4 Quincy  
Cherry Chase H.D.

The Montgomery County Historic Preservation Commission (HPC) has approved the revisions to the previously-approved Historic Area Work Permit (HAWP). The revised plans have been stamped as approved.

**PROPOSAL:** Revision to approved plans for new house

**Subject:** FW: 4 Quincy - Revised Elevations

A-3

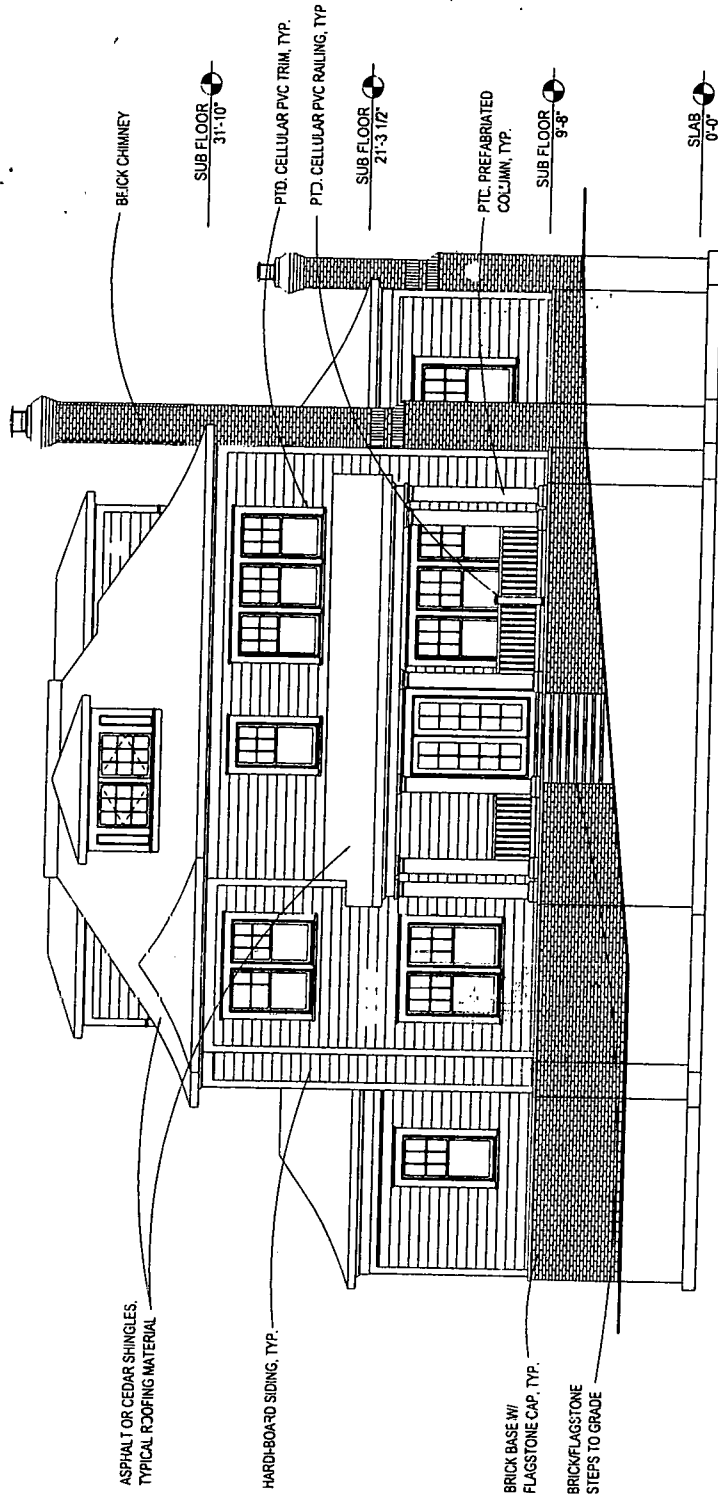
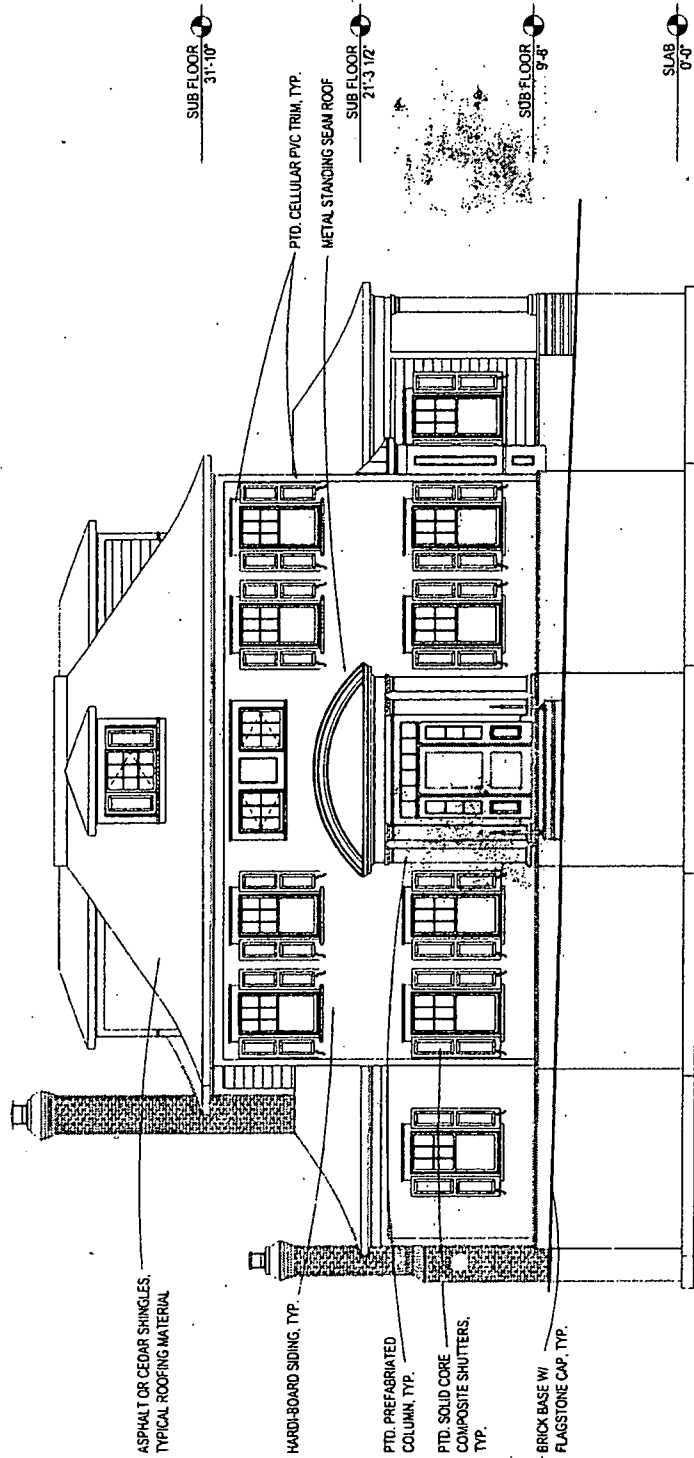
- removing shutters on two sides and rear of house.
- removing 2<sup>nd</sup> floor balcony at rear (therefore, change in porch roof form and no door to balcony),
- minor change to right side door.

We believe and we hope the HPC will agree that these are minor changes and do not in any way impact the front elevation of the house.

PROPOSED SITE PLAN

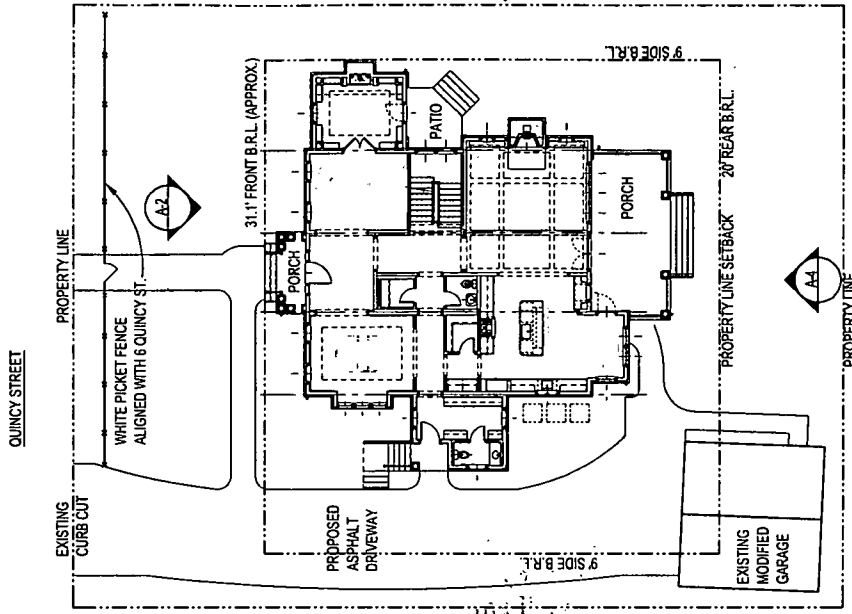
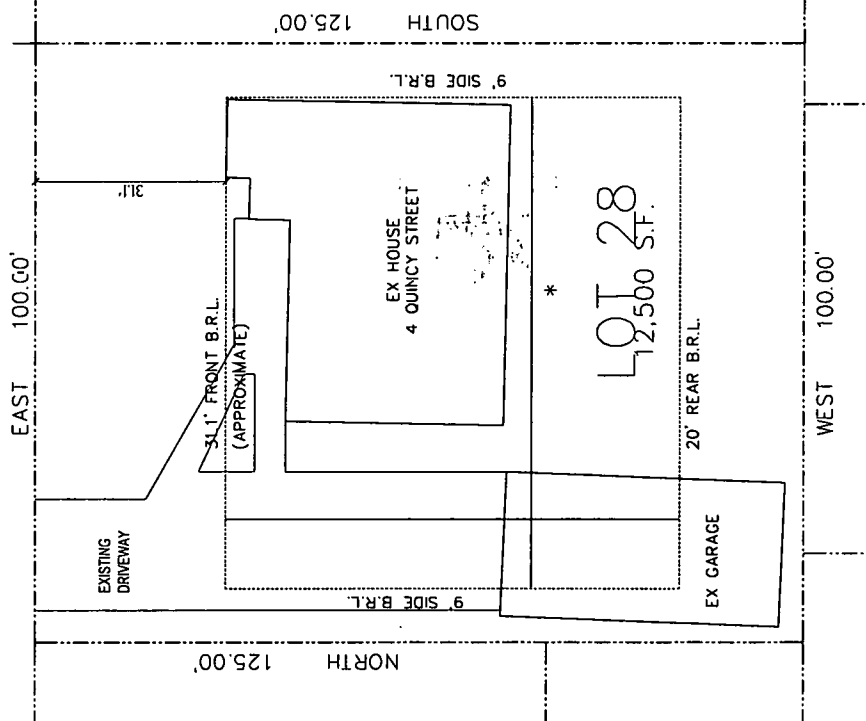
- Add concrete stairs with flagstone veneer to access the mud room porch from the driveway (the revised plans reflect the actual grade and storm water management and drainage plan required by the County)

FIRST FLOOR PLAN

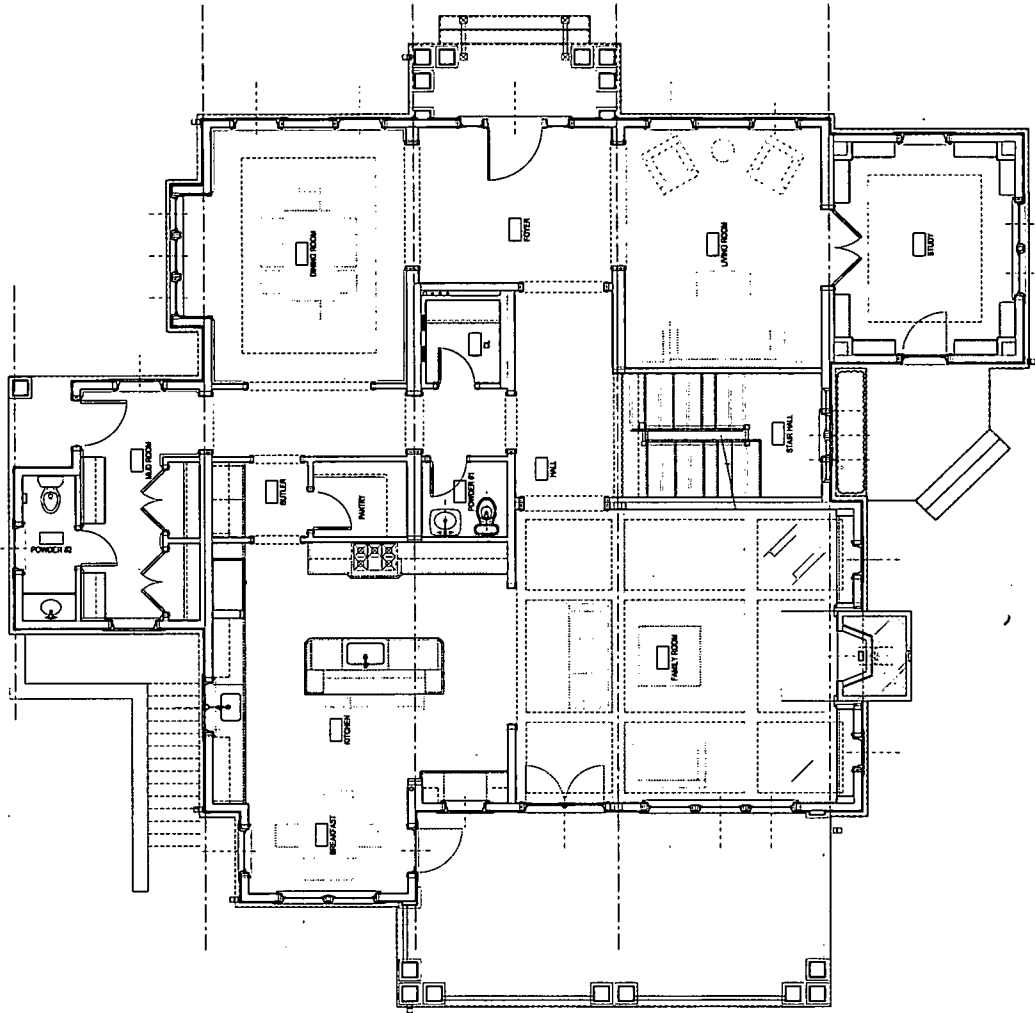
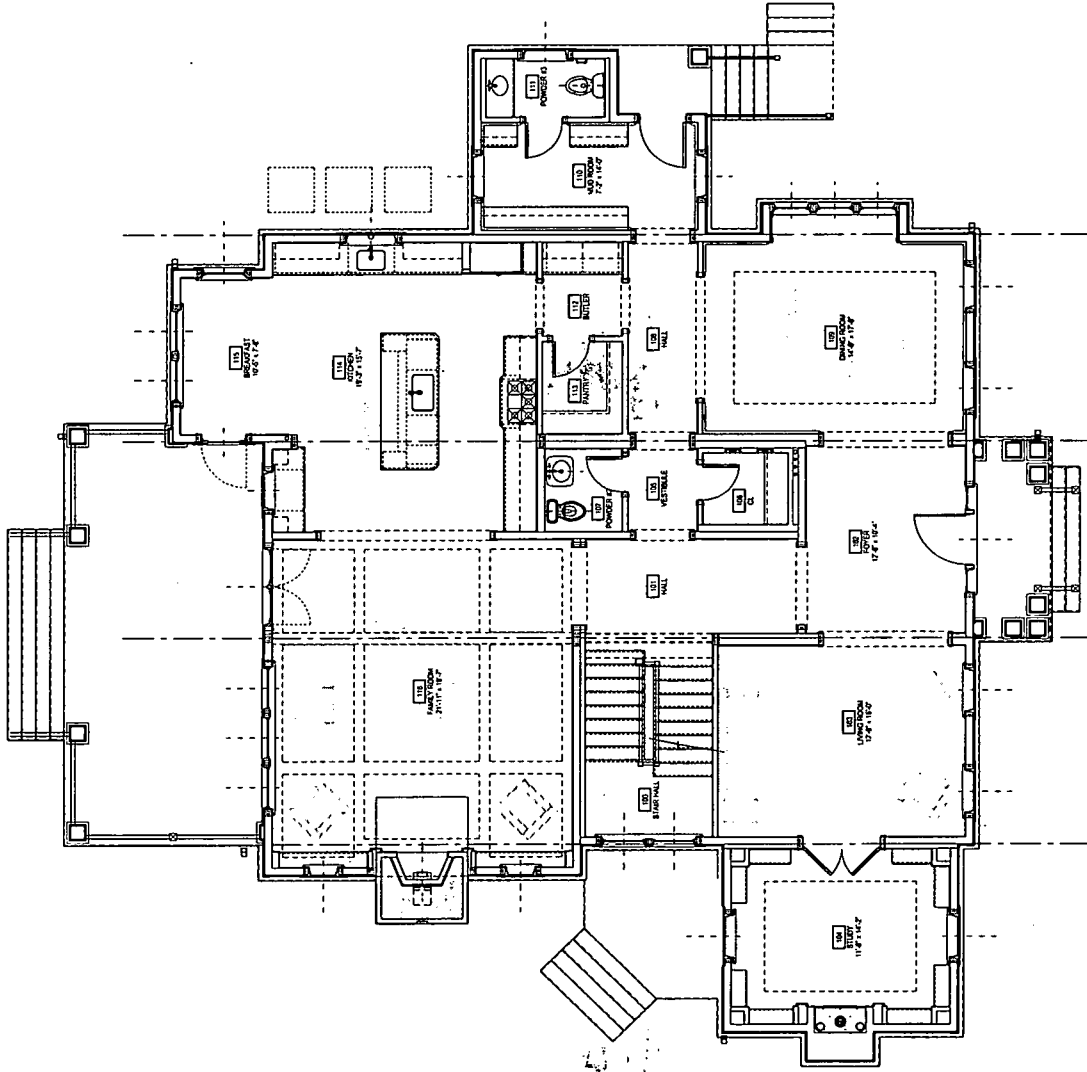
- Add masonry fireplace
- Replace a double basement window with French doors and steps
- Install three new windows at the basement level
- Enclose rear porch railing (access porch from rear)

RIGHT ELEVATION

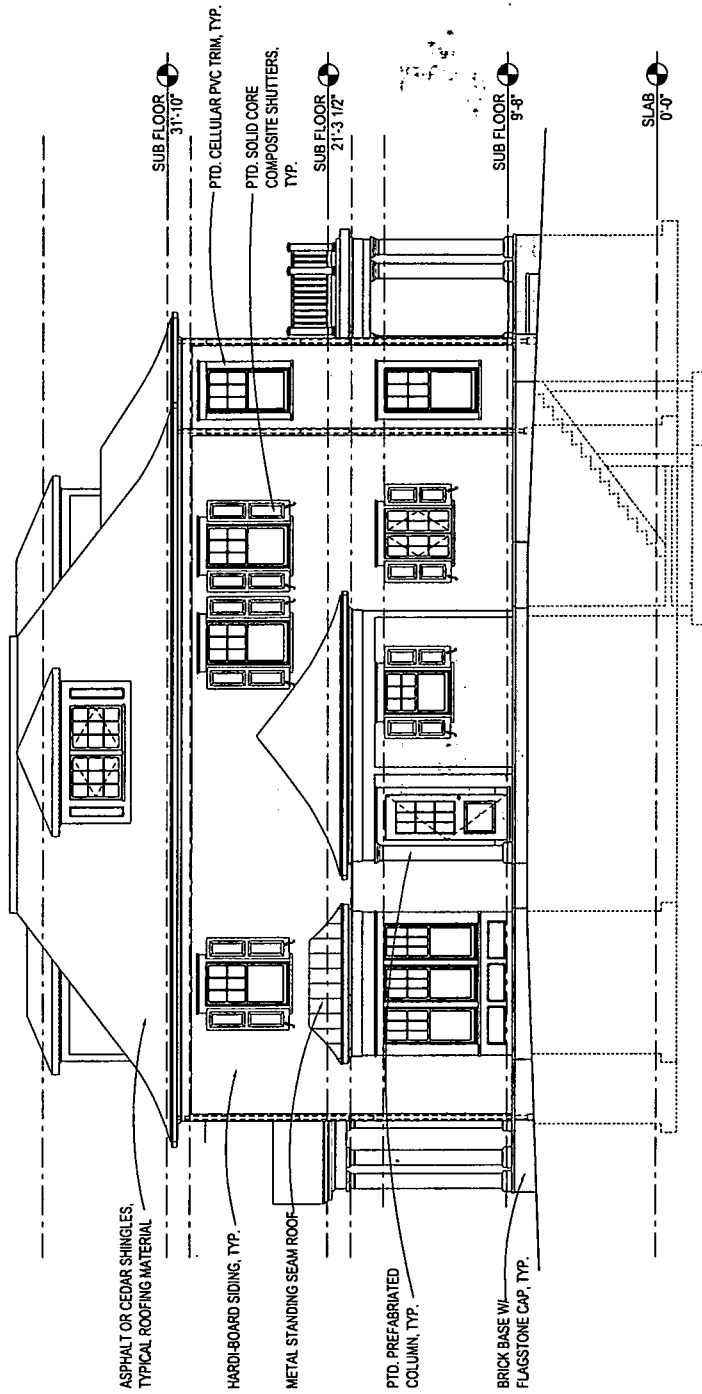
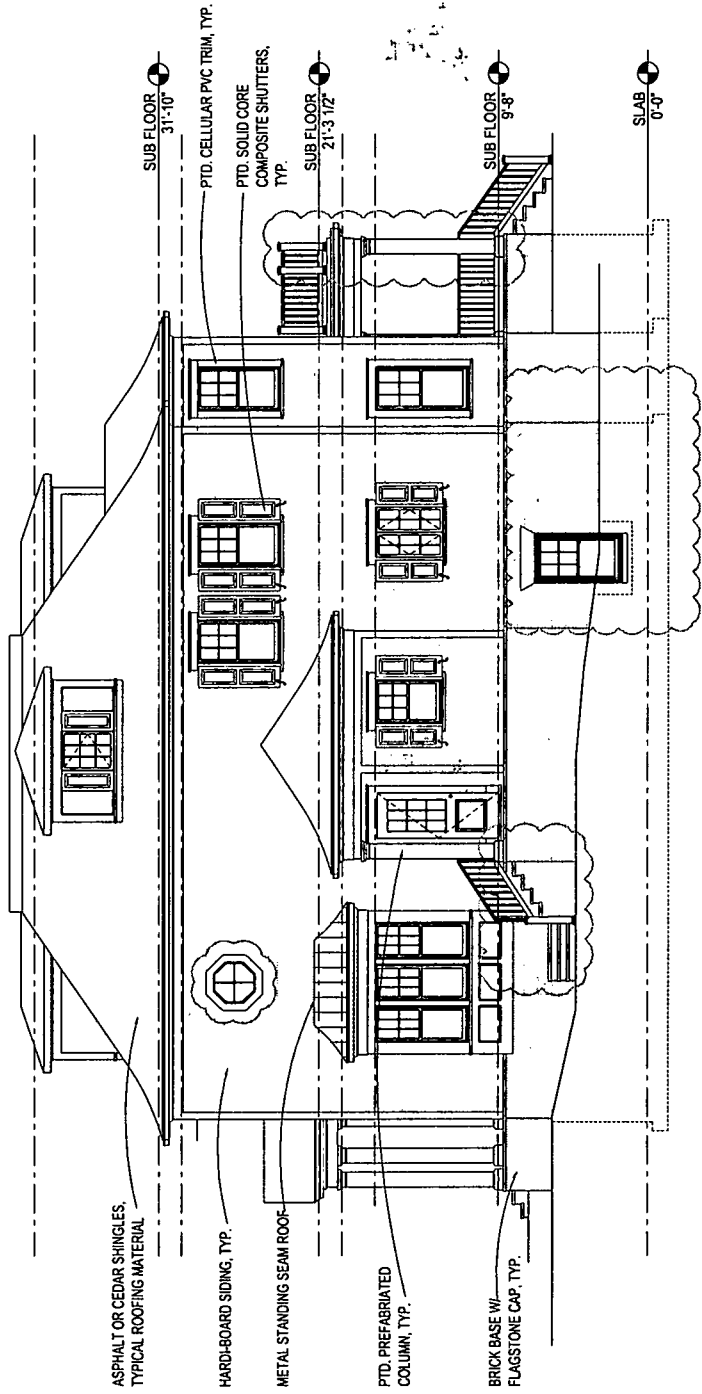
- Added masonry chimney for new fireplace in Study (left elevation)
- Added stairs to meet grade from mudroom (right elevation)
- Deleted areaway and steps down to basement (right elevation)
- Replaced double hung window with octagon window on 2<sup>nd</sup> floor (right elevation)
- Adjusted stairs from rear porch to grade (rear elevation)
- Deleted patio and doors off of Study (rear and left elevation)
- Replaced window with french door at stairs and basement windows (left elevation)
